PRODUCT BULLETIN (PBN1043-02)
November 30, 2010

Products Affected: WPT-800-RWAL (rev. 16 – 22),
WPT-800-RWAL24V (rev. 1 – 8), WPT-800-HUSB (rev. 17 – 20)

Figure 1. Sample HUSB and repeater layout

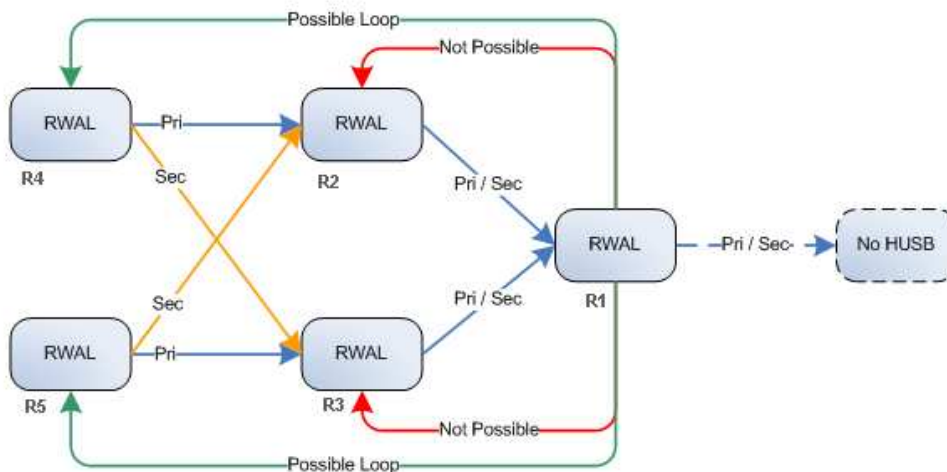
Under certain conditions, the repeaters can potentially re-organize to create a wireless loop. This loop will prevent WPT data from reaching the HUSB.

1. Make sure the HUSB is connected and the SBAC/GBC is powered
2. Turn off power to all repeaters
3. Turn on the power to the repeaters starting at the repeater closest to the HUSB and continuing in order of distance from the HUSB

Once the HUSB regains power, all repeaters should be powered off, then they should be turned back on starting with R1 then R2 and R3, then R4 and R5.
